Limited Visual Dam Safety Inspection Summary Report

MA-075

Reservoir 30

Limited Visual Dam Safety Inspection Conducted on: 05 April 2006

075 crest

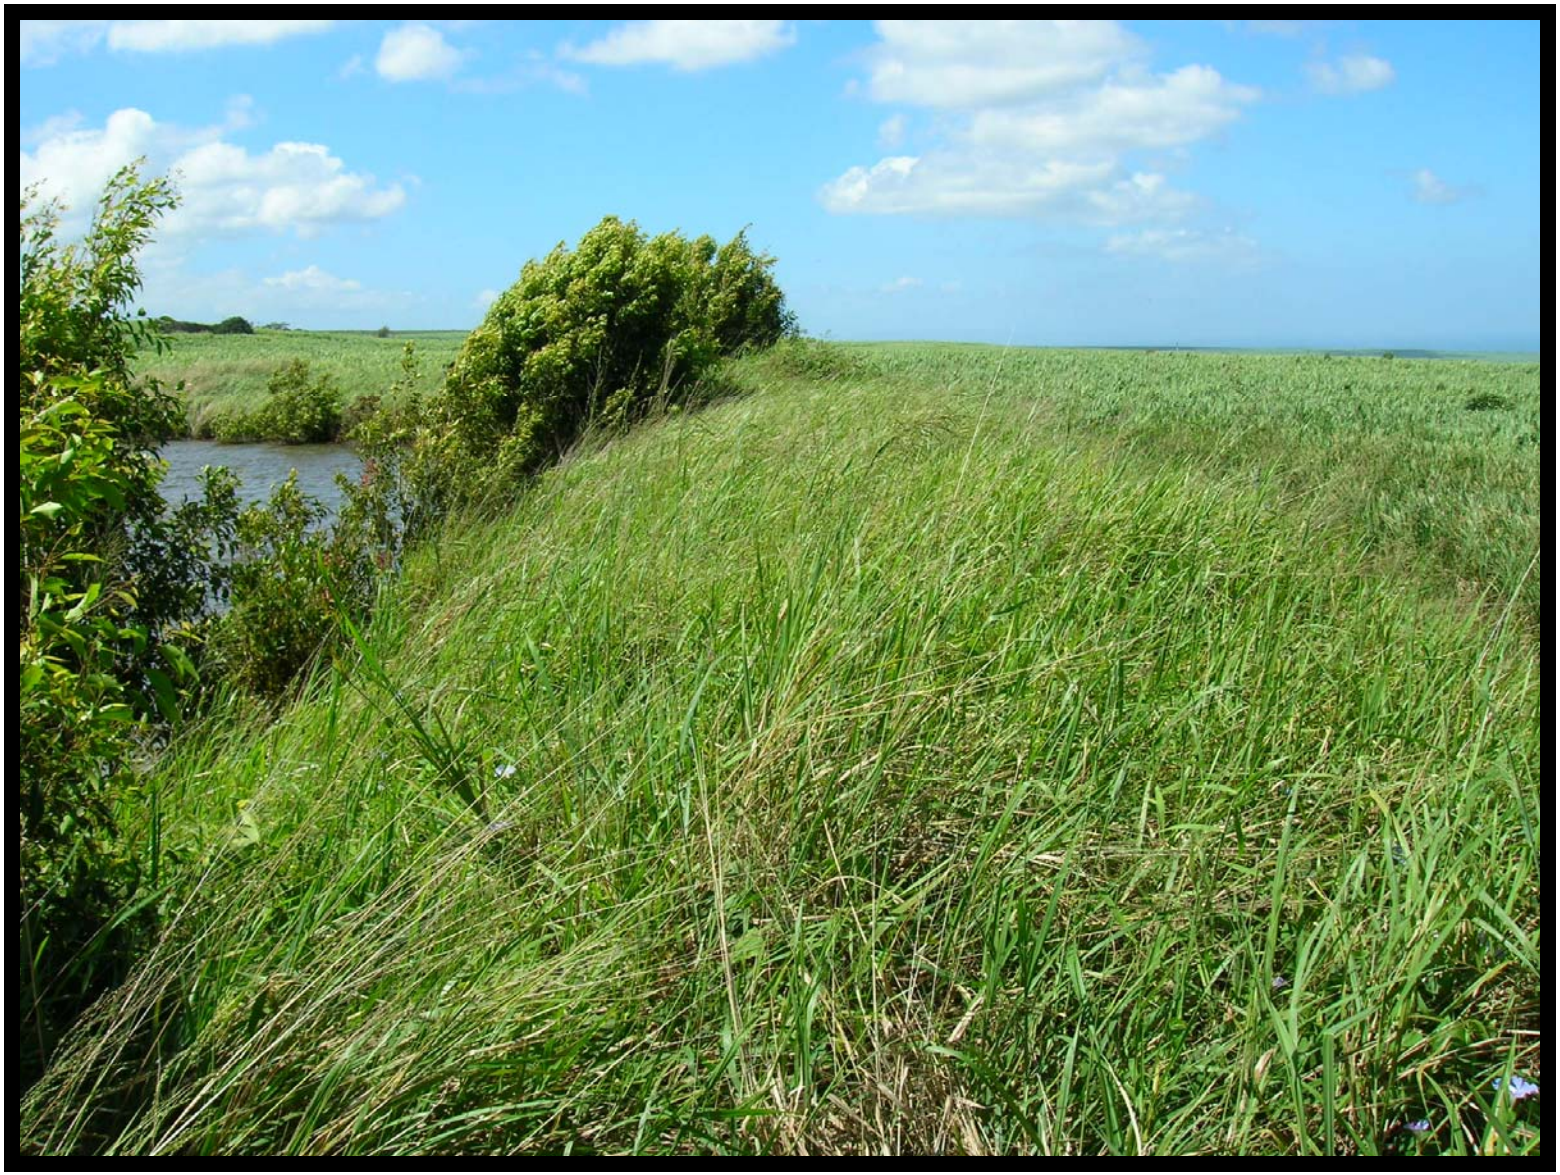
The dam crest was approximately 10 feet wide
There was no access to the crest.
Cracks were not visible, however the crest was not entirely visible.
Sinkholes were not visible, however the crest was not entirely visible.
Heavy vegetation was observed on the edges of the crest. These were primarily small woody vegetation and high grass.

a. The dam crest appeared to be in fair to poor condition and requires corrective action.
b. Portions of the crest were not visible due to high grass and bush vegetation. Clear high vegetation and maintain low to enable easy visual inspection.
c. Tree(s) were observed along the dam crest. Trees have been identified as the probably cause of piping failures, and can possibly cause sever damage to the embankment if they are uprooted during a high winds. Corrective action is required to remove the tree hazards from the dam. Acceptable remedies include removal of the tree and its root structure down to a 2" diameter and reconstructing the damaged embankment section. All repair work shall be accomplished as per the requirements of licensed geotechnical or structural engineer. Routinely monitor the damaged area for signs of settlement and seepage.

075 downstream slope

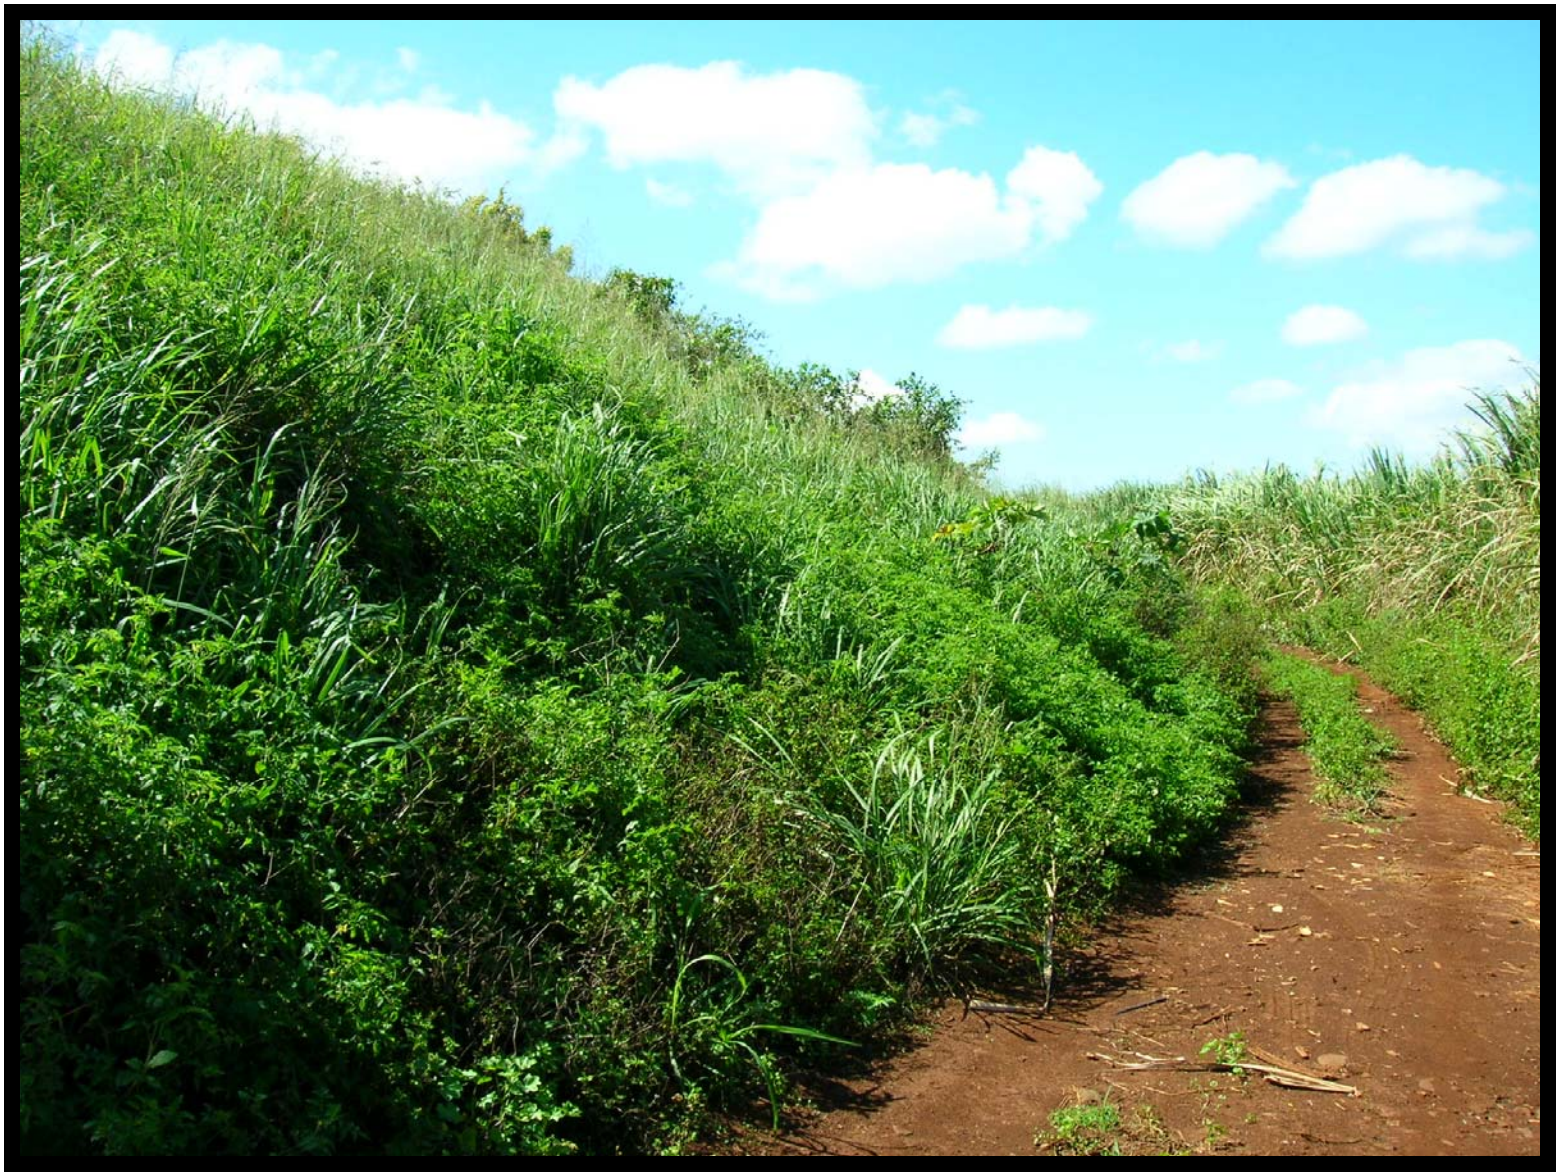
The downstream slope was in fair to poor condition and not visible due to heavy vegetation. The slope was very steep, around a 1 to .75 slope.
There was access to the downstream slope via a roadway along the downstream toe.
There was rip-rap slope protection observed on the downstream slope.
Erosion was visible on the downstream slope, two small scarps were noted.
Sinkholes were not visible on the downstream slope, however the slope was not entirely visible.
Vegetation was observed on the downstream slope. The majority of the vegetation was woody trees ranging from 2" to 2 feet in diameter.
Seepage was not visible on the downstream toe, however the slope was not entirely visible.

a. The downstream slope appeared to be in fair to poor condition and requires corrective action.
b. Gully erosion was observed on the slope, which requires maintenance and repair. Repair scarps.
c. The down stream slope was not visible due to high grass and bush vegetation. Clear high vegetation and maintain low to enable easy visual inspection.
d. Tree(s) were observed on the downstream slope. Trees have been identified as the probably cause of piping failures, and can possibly cause sever damage to the embankment if they are uprooted during a high winds. Corrective action is required to remove the tree hazards from the dam. Acceptable remedies include

e. The slope was very steep, around a 1 to 1 slope; further study is required to verify slope stability.
f. Vertical scarps and rodent holes should be repaired/filled.

075 inlet 3

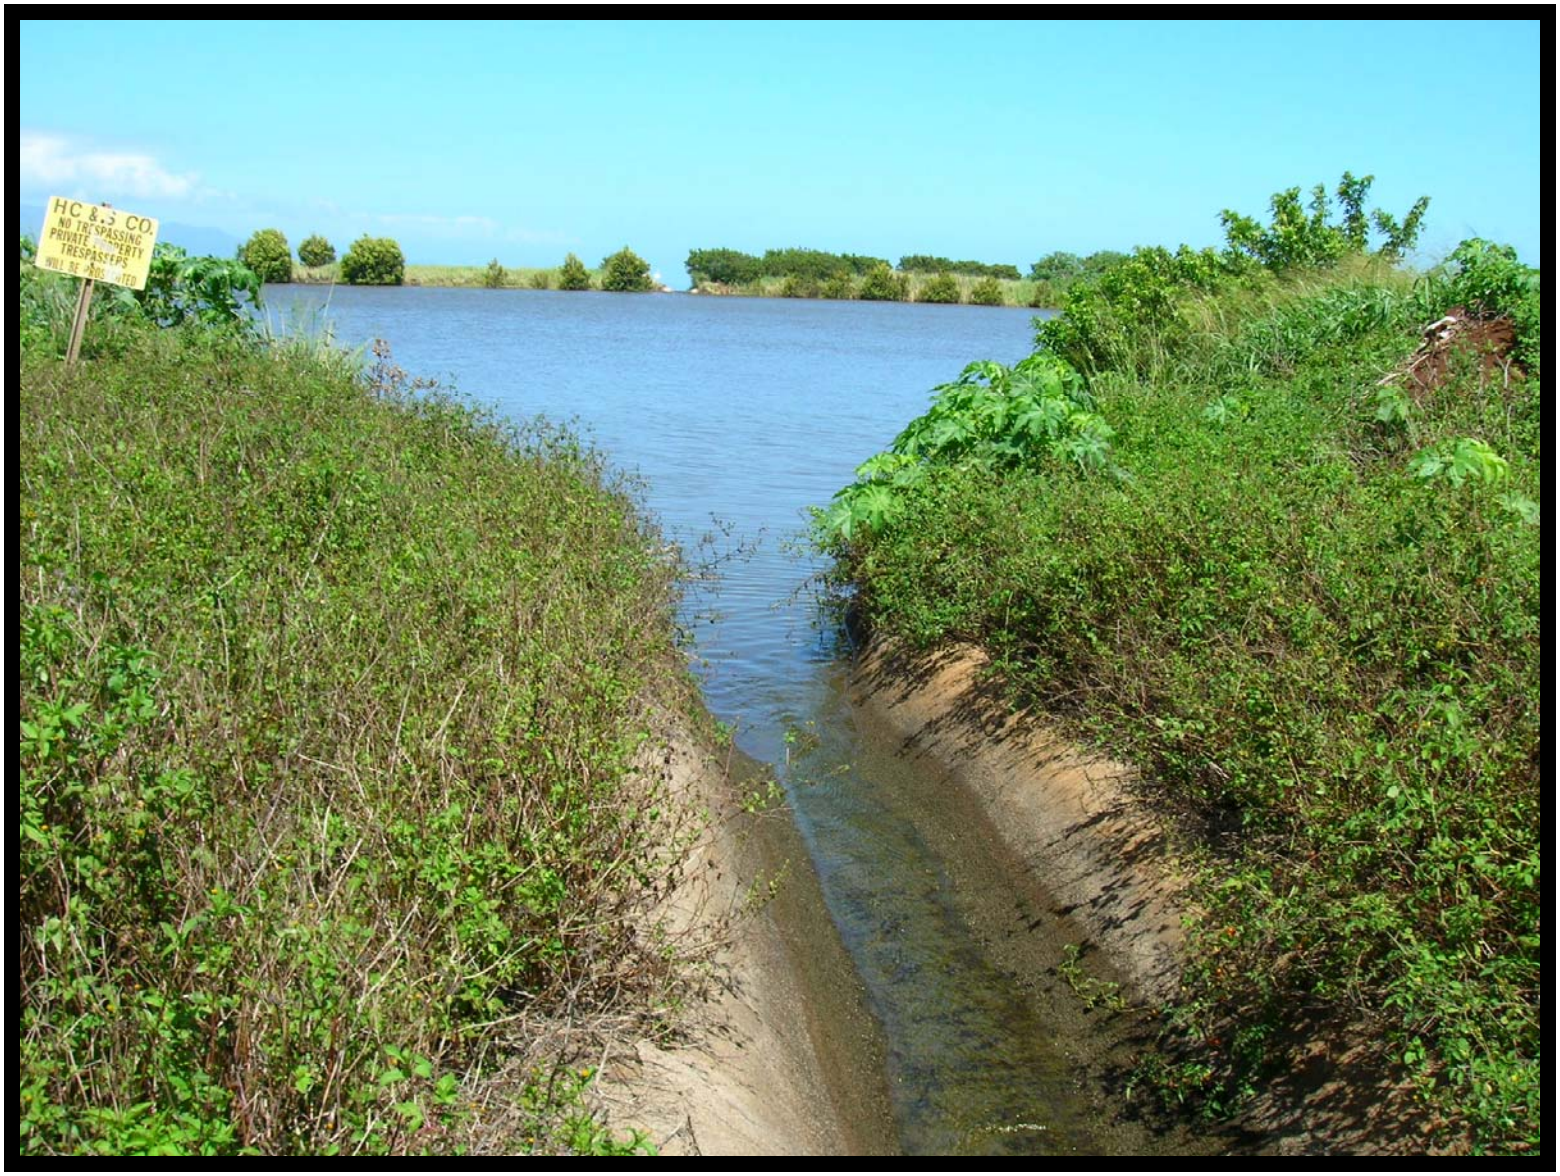
There is one 3ft by 3 ft gated concrete channel inlet feeding the reservoir. The intake has the ability to be shut off or diverted away from the reservoir during periods of heavy rains. This is done manually.

a. The intake works were not tested.
b. The intake works appeared to be in satisfactory condition, no corrective actions are required at this time.

075 spillway 4

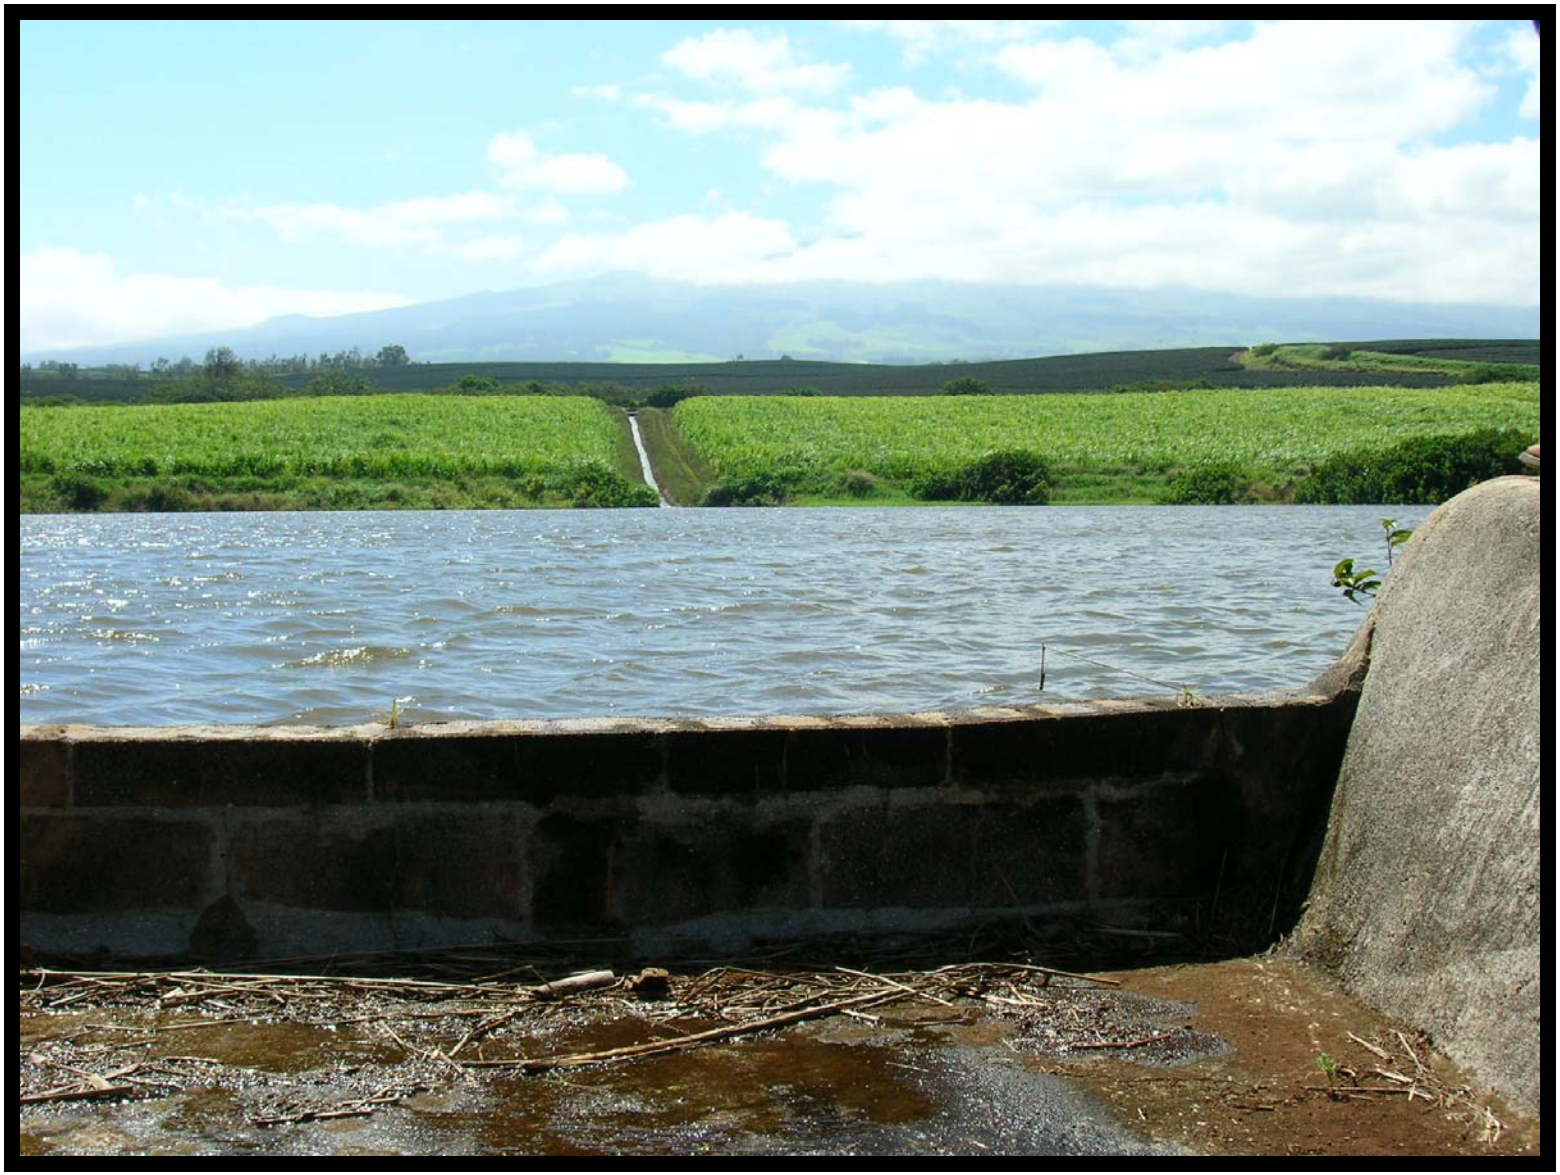
This spillway consisted of an 8ft by 3ft channel.
The spillway channel then feeds a drainage swale that runs along the base of the downstream toe, toward the right embankment and then head downstream.
The spillway approach was clear.
There was no erosion observed near the spillway.
Further investigations should be conducted to conclude the capacity of the spillway.

a. The Spillway appeared to be in fair to poor condition and requires corrective action.
b. Unclear if spillway is adequately sized. Spillway should pass the probable maximum flood. Verify spillway capacity and take corrective action as required.
